Bowie Mills Estates: Preliminary Plan No. 120140020

Staff Report Date: 10/10/14

Request to create four (4) lots from two existing undeveloped lots; located on the south side of Bowie Mill Road, approximately 300 feet east of Fraley Farm Road; 18.07 acres; RE-2 Zone; Upper Rock Creek Master Plan

Attachment A

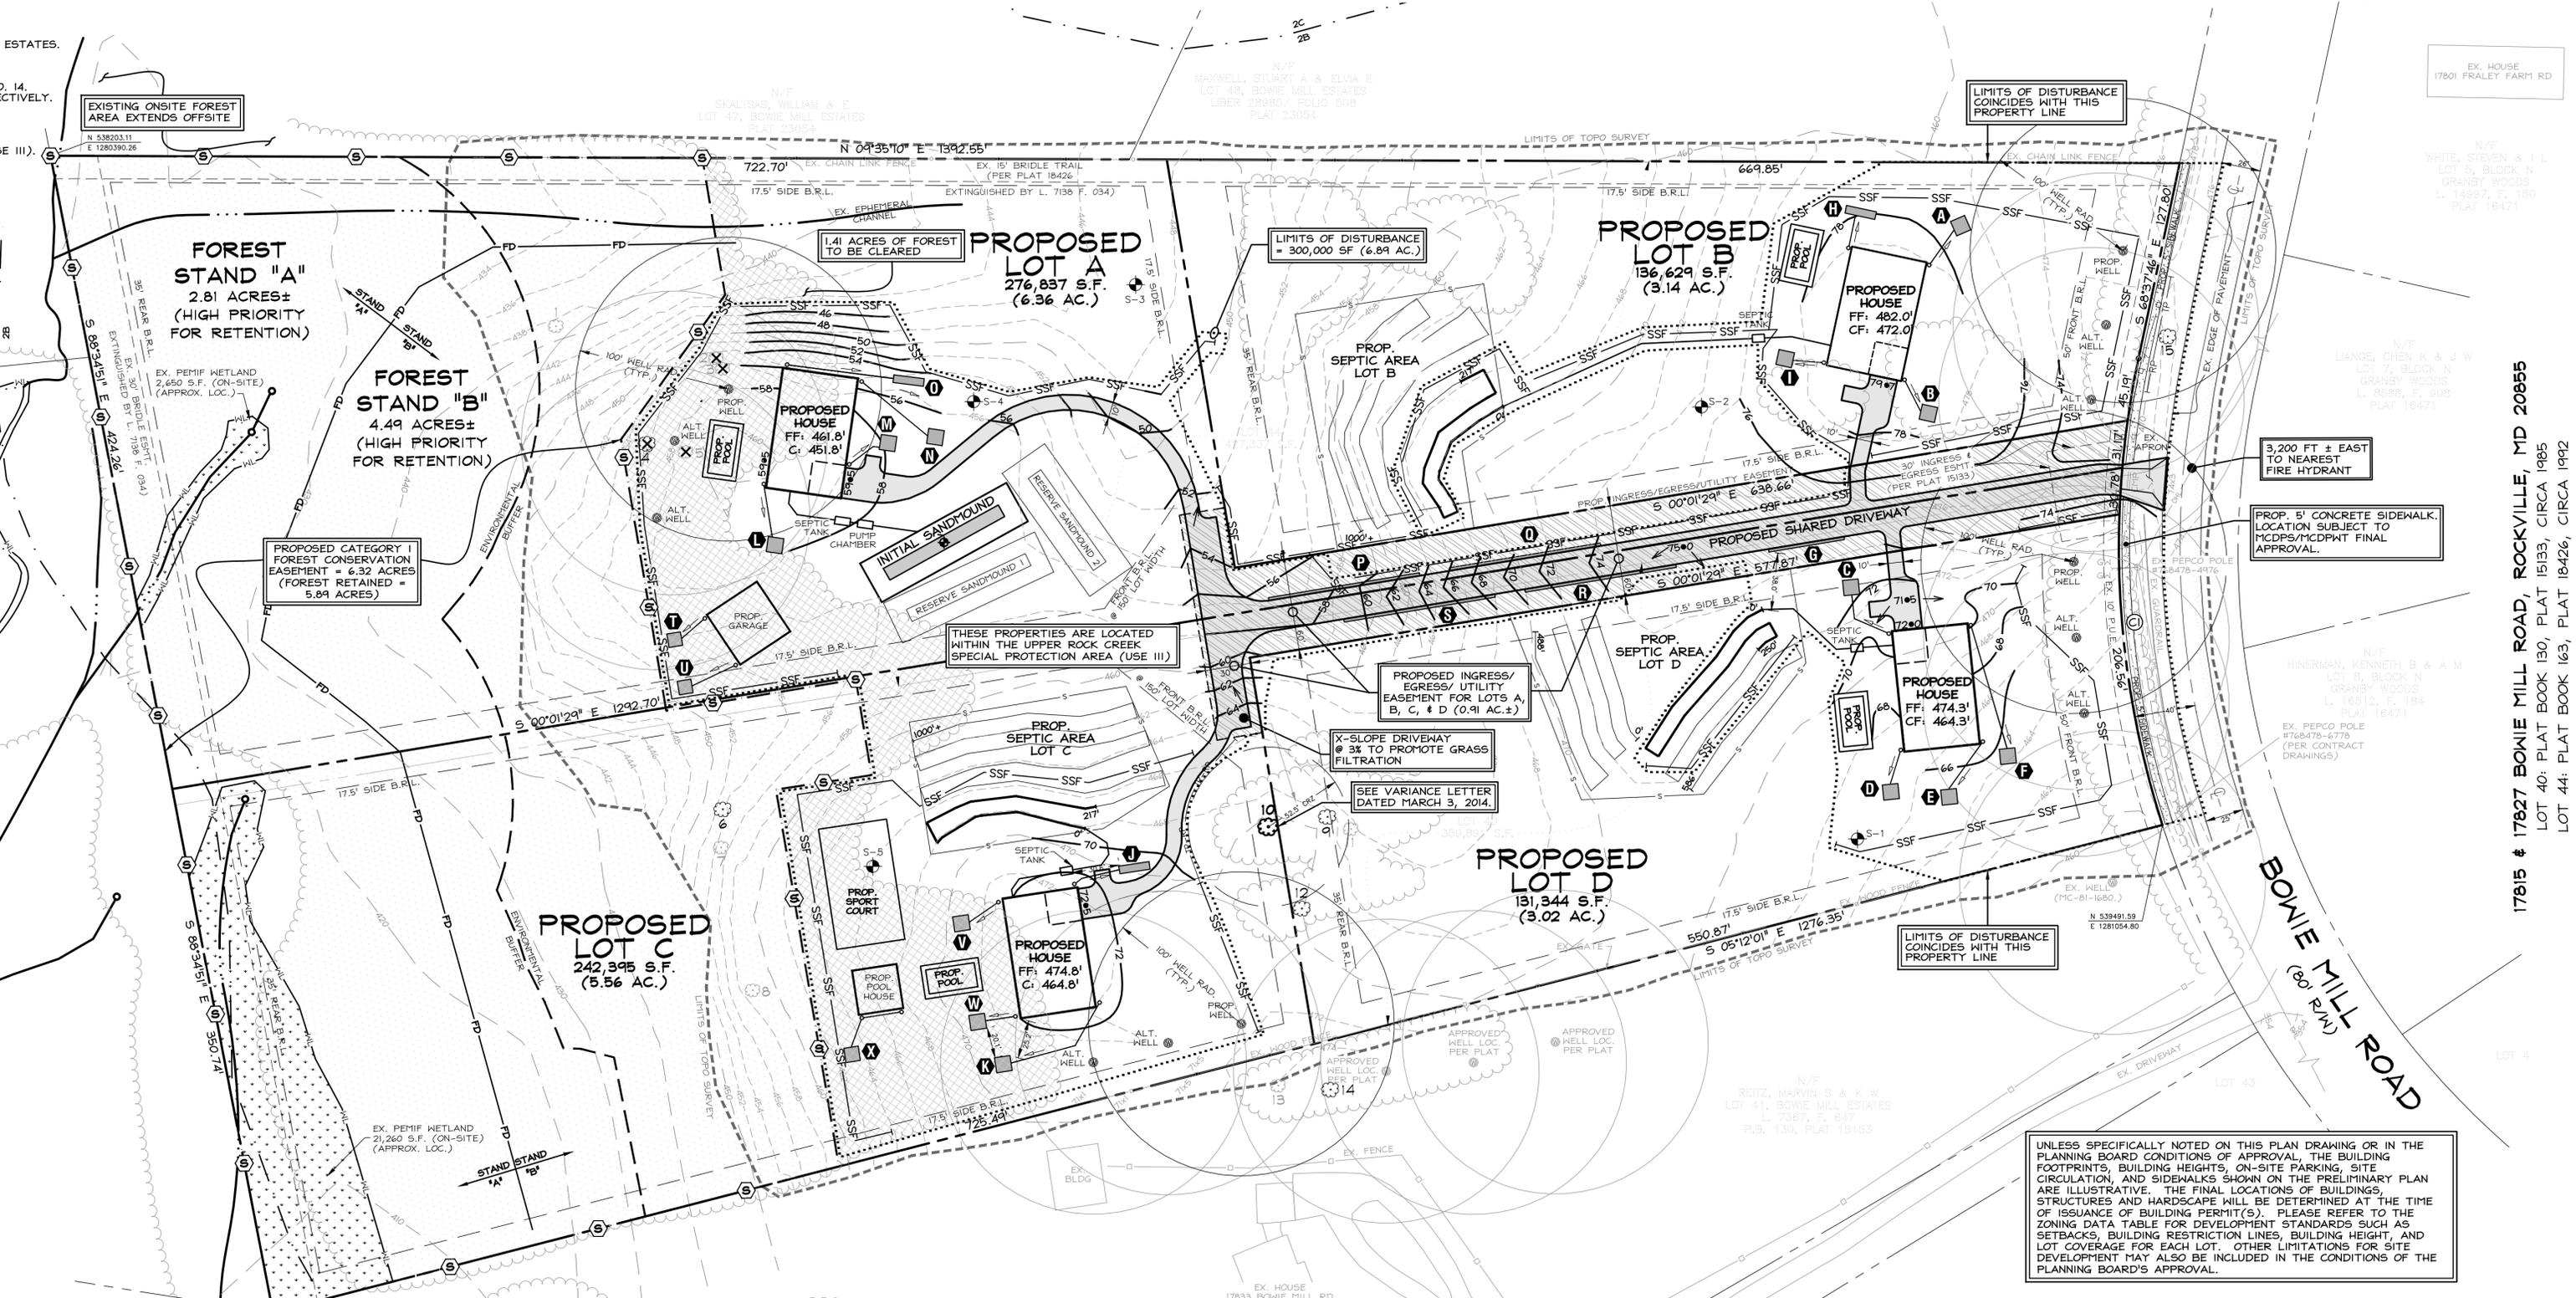
- 1) Approval under this Preliminary Plan is limited to four residential lots.
- 2) The Applicant must comply with the following conditions of approval for Preliminary Forest Conservation Plan No. 120140020, approved as part of this Preliminary Plan:

- 7) The certified Preliminary Plan must contain the following note:

“Unless specifically noted on the plan drawing or in the Planning Board conditions of approval, the building footprints, building heights, on-site parking, site circulation, and sidewalks shown on the Preliminary Plan are illustrative. The final locations of buildings, structures and landscape will be determined at the time of issuance of building permit(s) [or] site plan approval. Please refer to the zoning data table for development standards such as setbacks, building restriction lines, building height, and lot coverage for each lot. Other limitations for site development may also be included in the conditions of the Planning Board’s approval.”

- 8) Record plat must show necessary easements.
- 9) The record plat must reflect common ingress/egress and utility easements over all shared driveways.
- 10) The Subject Property is within the Magruder High School cluster area. The Applicant must make a School Facilities Payment to MCDPS at the elementary school level at the single-family detached unit rate for all units for which a building permit is issued and a School Facilities Payment is applicable. The timing and amount of the payment will be in accordance with Chapter 52 of the Montgomery County Code.
- 11) The Adequate Public Facility (APF) review for the Preliminary Plan will remain valid for eighty-five (85) months from the date of mailing of the Planning Board resolution.

# Attachment F

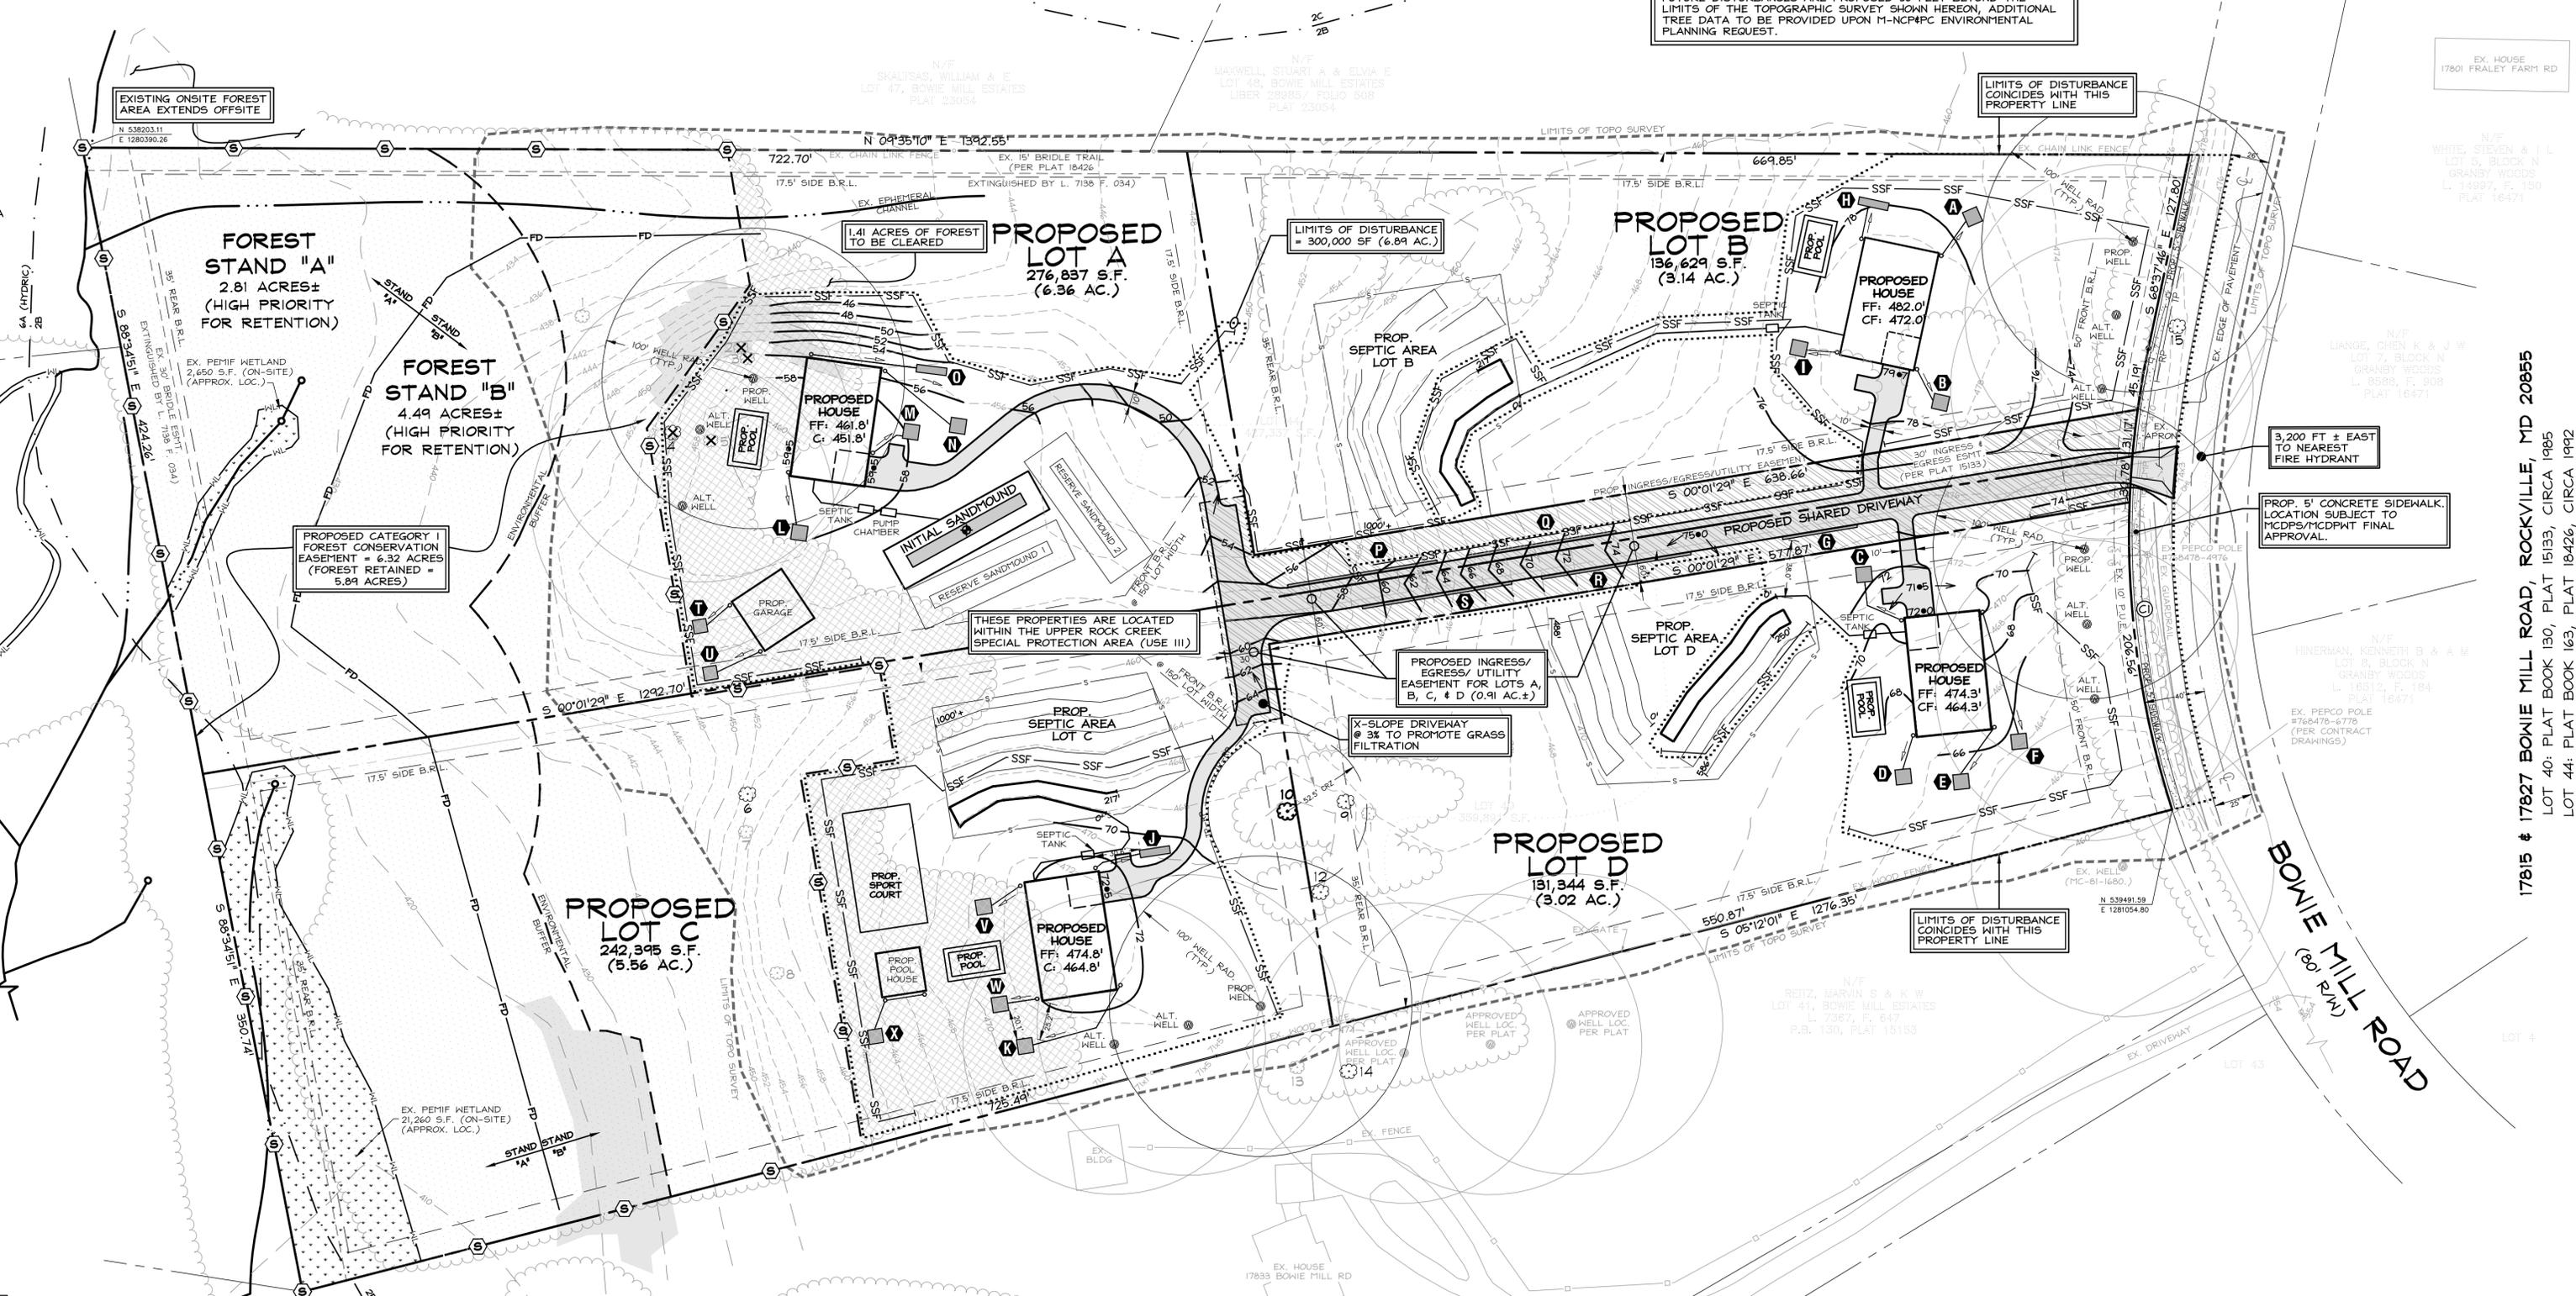
- a. Prior to Planning Board approval of the record plat, the Applicant must obtain staff approval a final forest conservation plan consistent with section 22A.00.01.09(B) of the forest conservation regulations.

- b. Applicant must place a Category I conservation easement over all areas of forest retention and environmental buffers.
 - c. A Category I Conservation Easement approved by the M-NCPPC Office of the General Counsel must be recorded in the Montgomery County Land Records by deed prior to demolition, clearing, or grading and the Liber Folio for the easement must be referenced on the record plat.

- d. Prior to any land disturbing activities the Applicant must delineate the Category I conservation easement area boundary with split rail fencing, or other staff approved equivalent.

- e. Revise the Forest Conservation Plan to show reforestation of all unforested Stream Valley Buffer areas. Stream Valley Buffer forest planting activities and access routes must ensure minimal disturbance to the Stream Valley Buffer.

- f. All reforestation plantings must be completed within the first planting season after issuance of the first sediment and erosion control permit.
 - g. The Applicant must obtain M-NCPPC approval of a five-year maintenance and management agreement prior to M-NCPPC accepting any on-site planting.

PROPOSED LOTS A, B, C & D  
**BOWIE MILL ESTATES**  
OLNEY (8TH) ELECTION DISTRICT, MONTGOMERY COUNTY, MARYLAND  
PRELIMINARY / FINAL WATER QUALITY PLAN

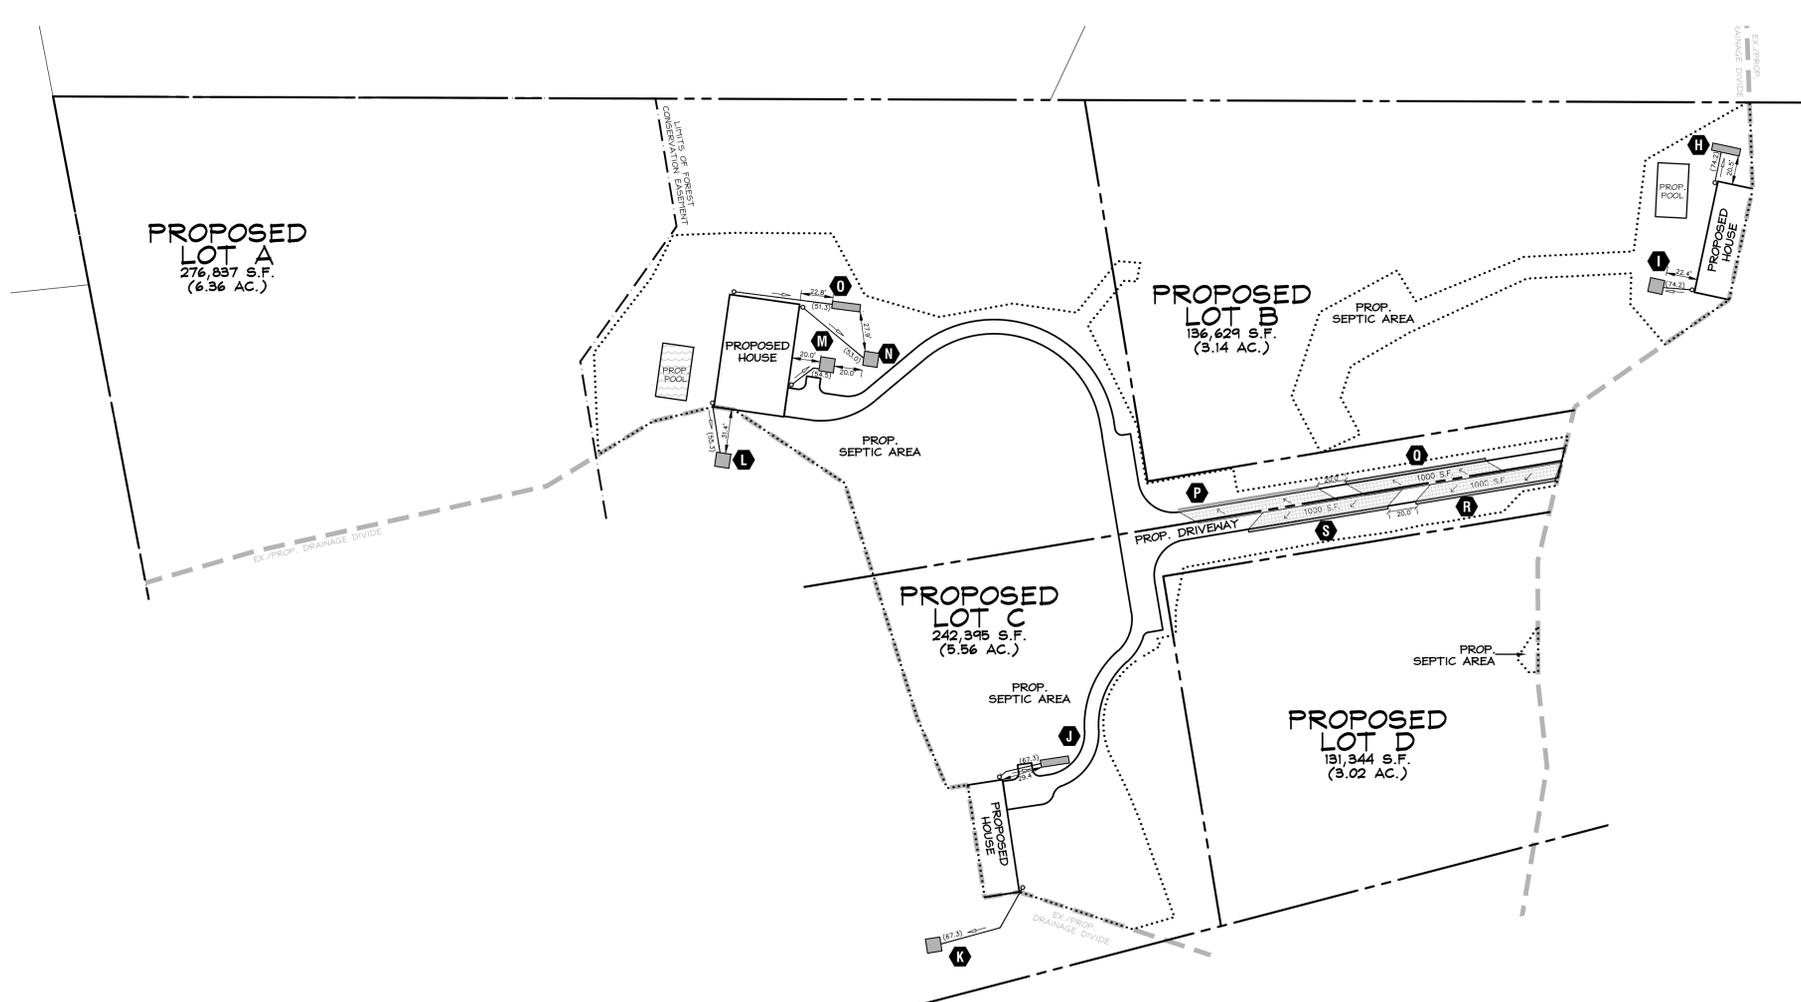
The following **conditions** will need to be addressed **during** the detailed sediment control/stormwater management plan stage:

1. A detailed review of the stormwater management computations will occur at the time of detailed plan review.
2. An engineered sediment control plan must be submitted for this development.
3. Micro-infiltration areas P, Q, R and S need to be moved up or down slope to relatively flat locations. This may require shortening and widening the infiltration area. Bio swales also appear to be feasible in these areas.

The following **conditions** will need to be addressed **during** the detailed sediment control/stormwater management plan stage:

1. A detailed review of the stormwater management computations will occur at the time of detailed plan review.
2. An engineered sediment control plan must be submitted for this development.
3. Micro-infiltration areas P, Q, R and S need to be moved up or down slope to relatively flat locations. This may require shortening and widening the infiltration area. Bio swales also appear to be feasible in these areas.
